## EIS Errors

The EIS is riddled with errors, mistakes, and very biased self-serving statements, which makes one wonder which pieces of evidence are factual.

*“Development application, Peak Tower, North Elevation, proposed building profile overlay*

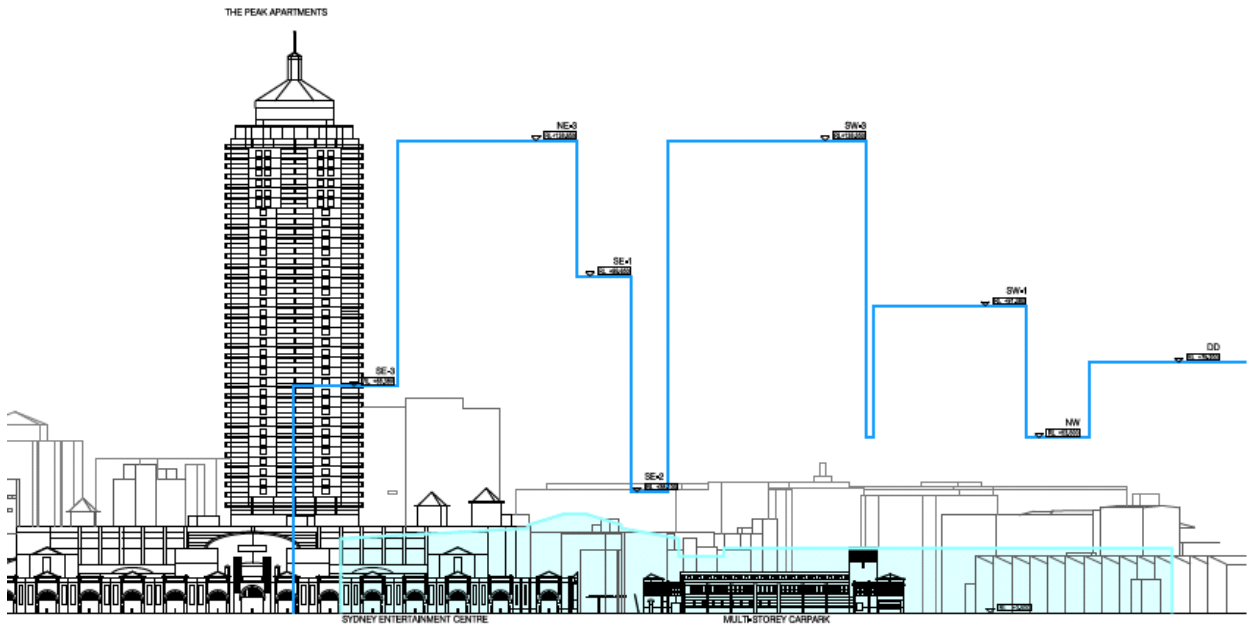
Are these errors or just a convenient place to hide them ?

The following figure – buried in SSD 5755 illustrates the size of the proposal in relation to The Peak.

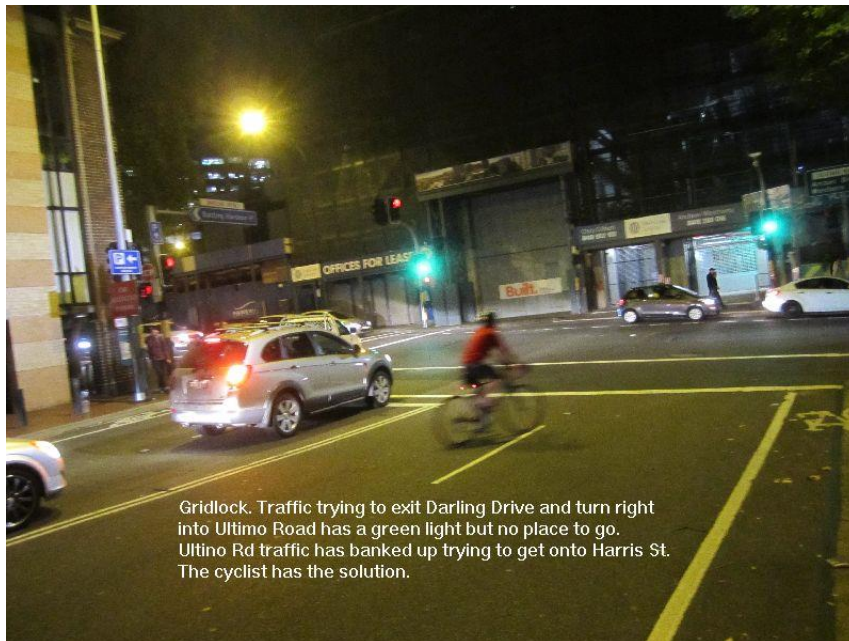
Darling Drive will be reduced to one lane each way EIS 2/4 P71: “ Darling Drive has reduced the number of lanes and tightened the road corridor to provide a more attractive setting for the student accommodation”

One of those is at Ultimo Rd, where the study states that 30% of the traffic flow to and from Darling Drive will be via Ultimo Road (section 7.1.1). Yet amazingly no traffic studies are done on this intersection !

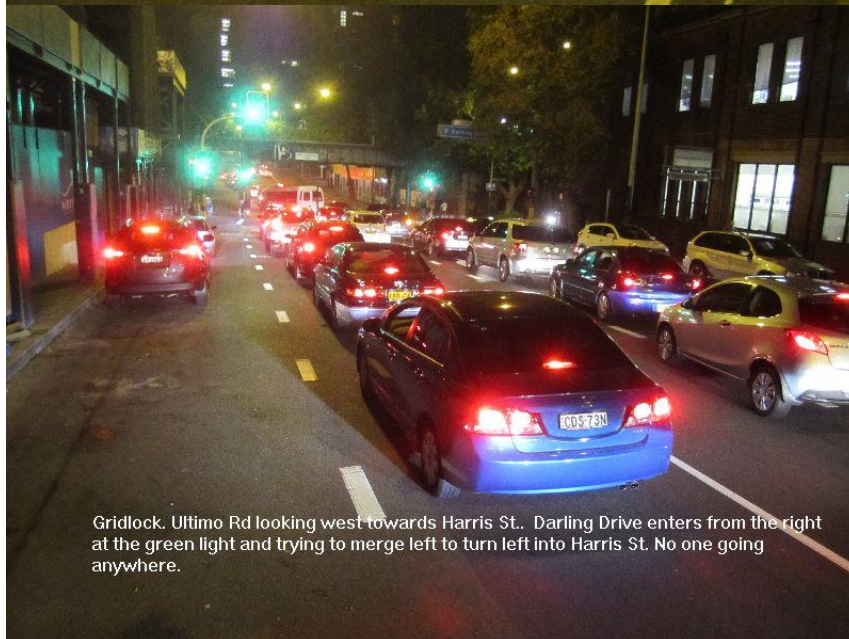
Gridlock. Traffic trying to exit Darling Drive and turn right into Ultimo Road has a green light but no place to go. Ultimo Rd traffic has banked up trying to get onto Harris St. The cyclist has the solution.

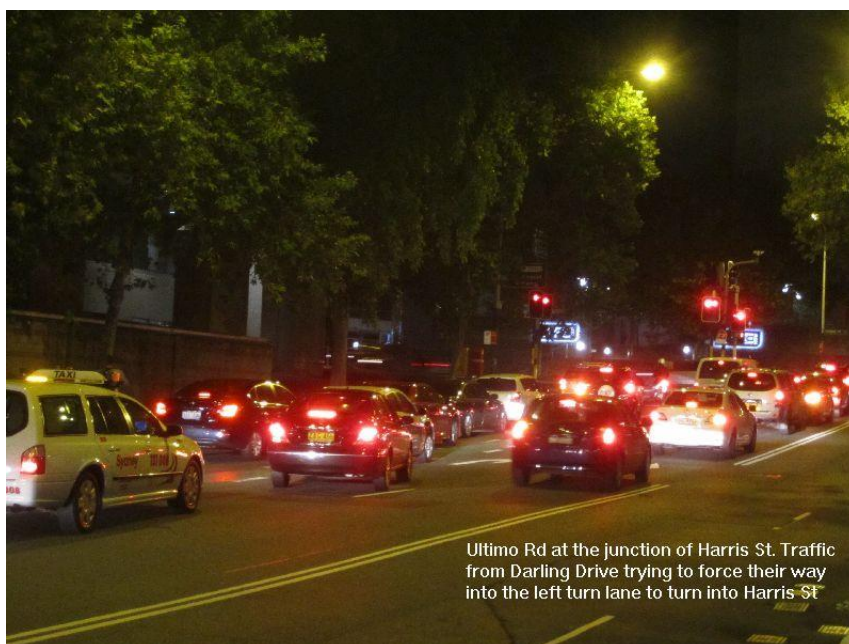
Gridlock. Ultimo Rd looking west towards Harris St.. Darling Drive enters from the right at the green light and trying to merge left to turn left into Harris St. No one going anywhere.

Ultimo Rd at the junction of Harris St. Traffic from Darling Drive trying to force their way into the left turn lane to turn into Harris St

Peak Level 42

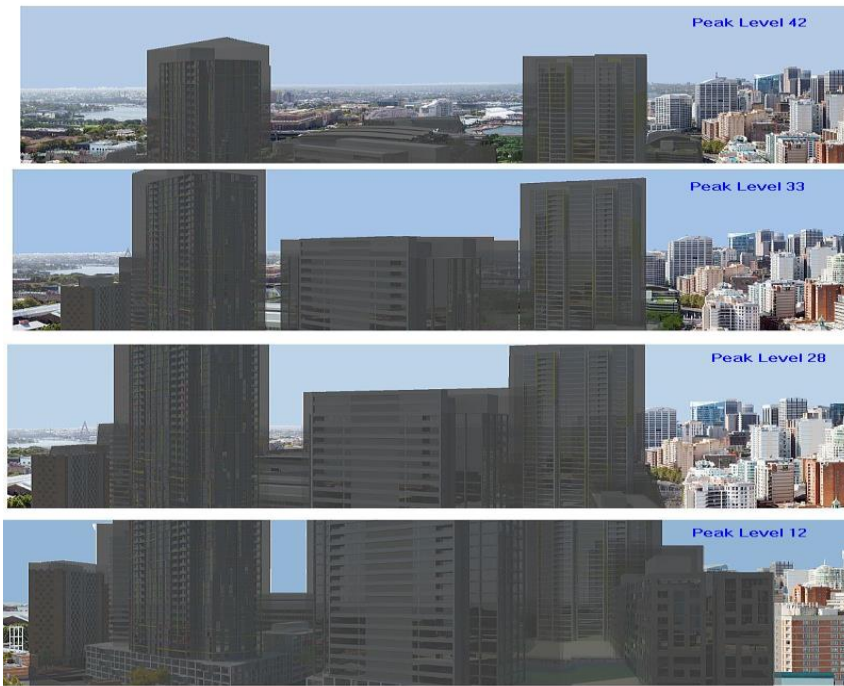
- Does not respect privacy and overlooking.
- Does not respect view sharing with existing buildings: 231 units in the Peak alone will lose an average of 60 degrees of views.
- Does not differentiate between new public views and new private views when preference should be considered for the **public** good.
- Proposes nine towers south of Pier St, where the Woods Bagot report suggests 2 and the City of Sydney recommends only 3
- Does not introduce setbacks for towers
- Does not allude to any concept of human scale

DMC acknowledge and restate those principles (Design Report p 50) and add that *“Towers are to be slender in form and should not come to the ground, but rise from urban blocks”* and then design virtually every tower originating with a sheer wall from the street !
